# SERVICE BULLETIN

## REPLACEMENT OF FUEL PUMP

### FOR ROTAX<sup>®</sup> ENGINE TYPE 912 (SERIES) SB-912-053

(see Fig.1)

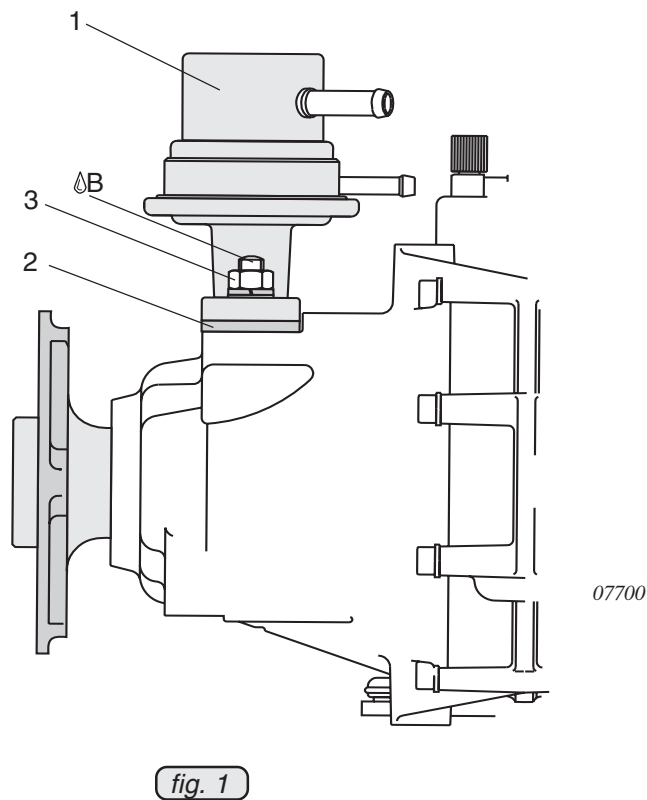
1. Remove fuel pump (1).
2. Gasket (2) replaced by new part.

■ **CAUTION:** Install new gasket supplied with new fuel pump. Do not reuse old gasket.

◆ **NOTE:** On the sealing surfaces of the gearbox housing and the fuel pump no sealing compound has to be used.

3. Install fuel pump.

4. Tighten uniformly hex. nuts (3) with LOCTITE 243. Tightening torque 15 Nm (133 in.lb).

◆ **NOTE:** The additional use of LOCTITE 243 should be applied at each removal/replacement of the fuel pump and/or gasket. A rework of already installed fuel pumps part no. 892542 and 892546 is not necessary.
